Access Compliance Report

Public Rights-of-Way

(Curb Ramps)

Intersection ID: 50302	Main Street: PINE_CHAPEL_DR	Cross Street: PINE_TERRACE_CT	Location: SW
ADA ID: FCA7D4B8D0D6	Ramp Type: Perp	Initial Pass/Fail: Pass	Overall Compliance: No
Severity Score: 5.25			
Codes/Mitigation Info/Possible Solution		Field Measurements/Component Compliance

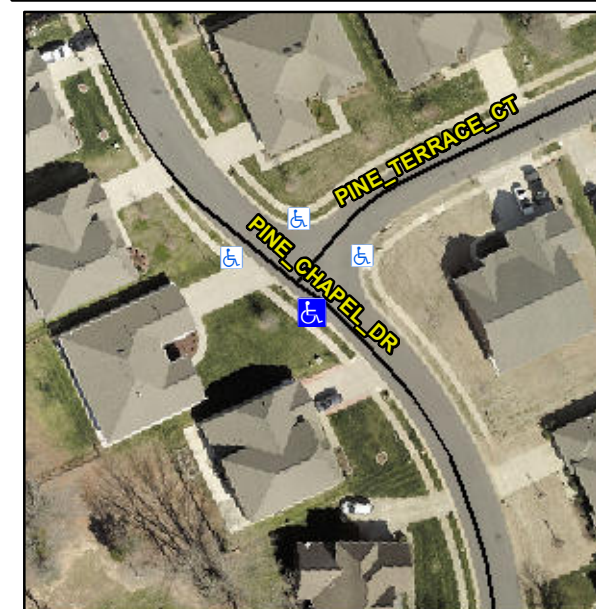
**Not Found, R304.5.3, R305.2,
R304.5.4**

**Remove & Replace Entire Ramp.
Remove & Replace Gutter.**
